Block Island Power Company - Docket No. 4688

Docket No. 4688

BLOCK ISLAND POWER COMPANY'S RESPONSES TO THE DIVISION OF PUBLIC UTILITIES AND CARRIERS' FIRST SET OF DATA REQUESTS DIRECTED TO BLOCK ISLAND POWER COMPANY

BIPCO Exhibit 1.2

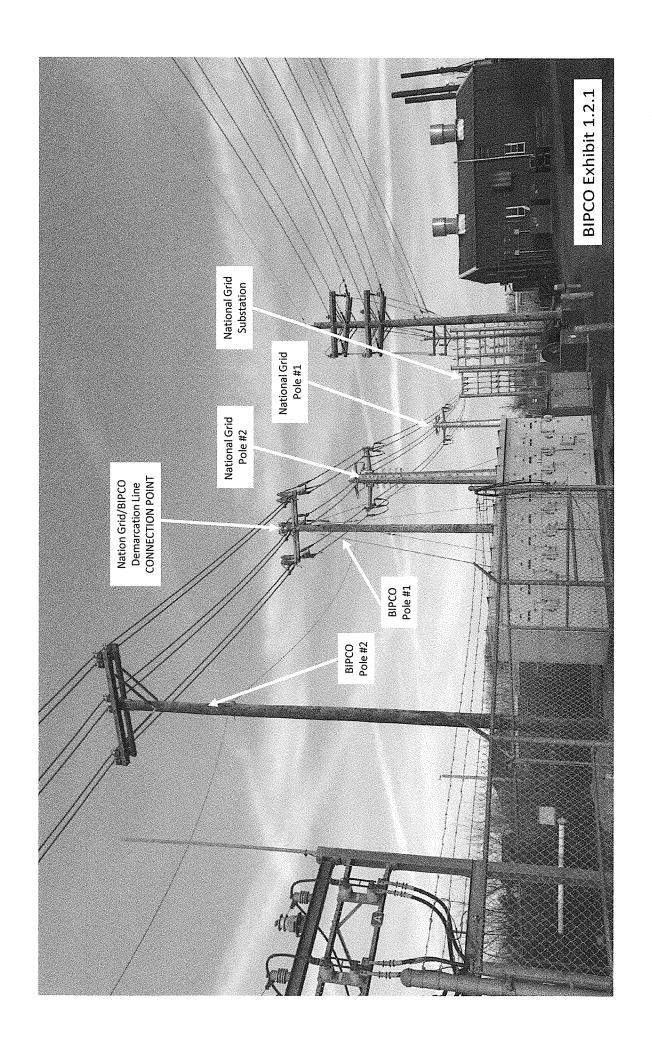
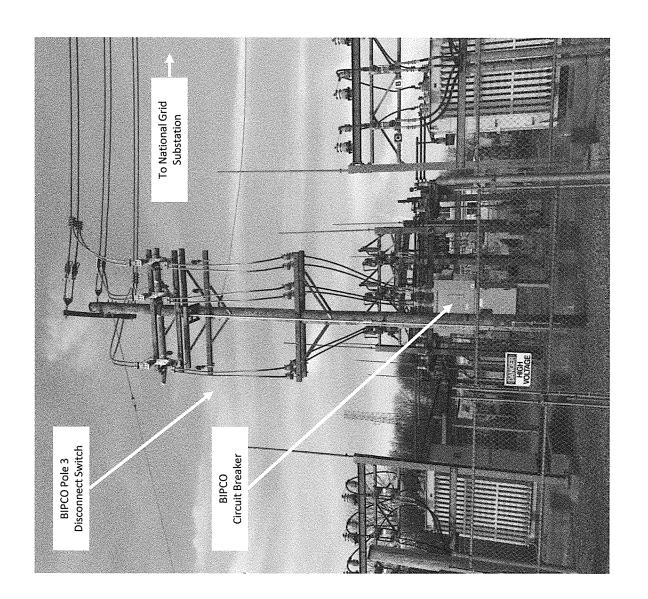
2. Please provide a detailed one-line station diagram of the existing BIPCO substation(s) where BIPCO will interconnect to National Grid, including but not limited to property boundary, buses, switchgear, circuit breakers, transformers, metering equipment, and the get-away connection(s) to the National Grid substation referenced in question 1 above.

BIPCO has provided a BIPCO facilities one line diagram (BIPCO Exhibit 1.2) that shows the electrical equipment in the existing BIPCO substation, the new National Grid Substation and the interconnecting overhead line that connects the two substations. [Note that this exhibit contains privileged and confidential information and BIPCo requests privileged and confidential treatment under Rule 1.2(g)]. The disputed facilities are within the red cloud and labeled "DISPUTED FACILITIES PAID FOR BY BIPCO". The ownership demarcation line is shown in the center of the interconnecting overhead line and is marked "National Grid/BIPCO Demarcation Line, CONNECTION POINT". The overhead line that connects the two stations is operated at 2.4kV DELTA. The overhead line consists of five spans of conductor, approximately 100'-130' in length each. The "CONNECTION POINT" is at the first wood pole that is owned by BIPCO.

- 5a) The back-up transformer has not been purchased by National Grid, nor are there any immediate plans or request to order one, until a decision has been reached in this matter. The transformer that BIPCO wishes to be backed up is shown in Exhibit 1.2, located in the blue clouded area. The transformer is a 34.5 kV Wye / 2.4 kV Delta transformer rated at 6/7.5 MVA.
